DESCRIPTION

On the vehicles affected by this bulletin, a corrective measure is required due to bolts coming loose at the radiator fan clutch tripod attachment to the radiator. Bolts tend to get loose because they are tightened on a part made of rubber. Addition of four (4) locknuts (jam nuts) will prevent bolts to loosen and consequently, the radiator fan from striking the radiator core if the assembly fails.

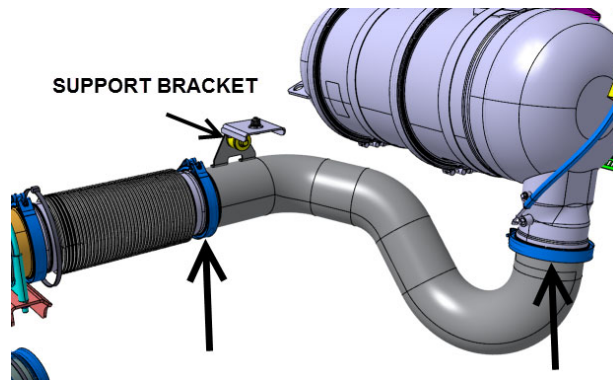
3. **H3 VIP CONVERSION SHELLS.** The section of the exhaust pipe located between the DPF and the flexible section above the turbo must be removed to gain access to the tripod upper support.

a. Clear the two (2) V-band clamps hidden under the insulating blanket at the junction with the DPF and at the junction with the exhaust flexible section.

b. Undo the two (2) V-band clamps identified on the image.

c. Unscrew the nut at the support bracket.

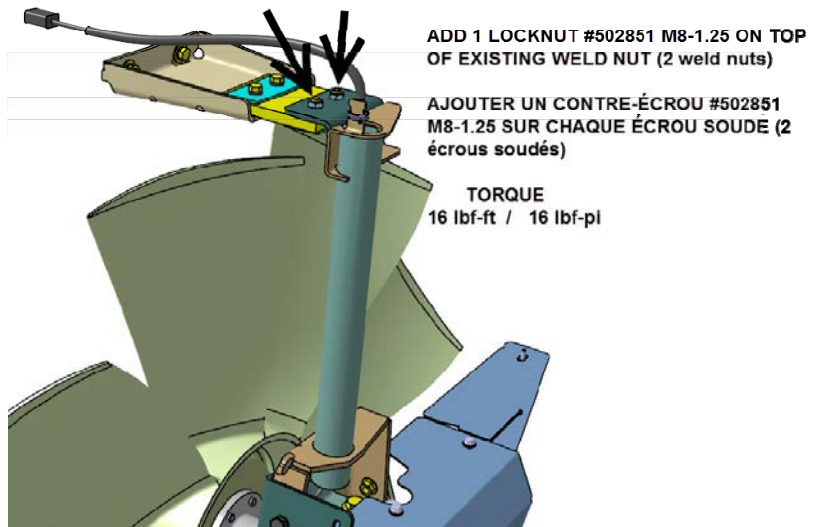
4. **ALL TYPES.** Add two locknuts #502851 as described on the image at right. **If needed, tighten the bolt a little bit more to show more threads.**

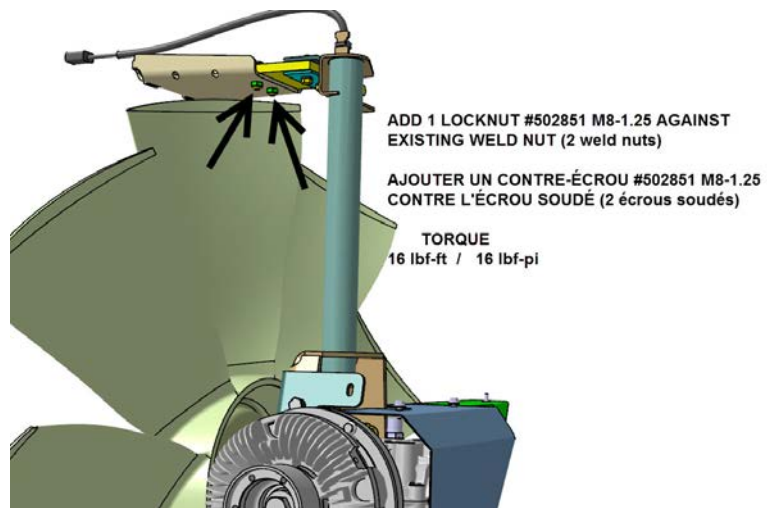
5. **ALL TYPES.** Add two locknuts #502851 as described on the image at right. **If needed, tighten the bolt a little bit more to show more threads.**
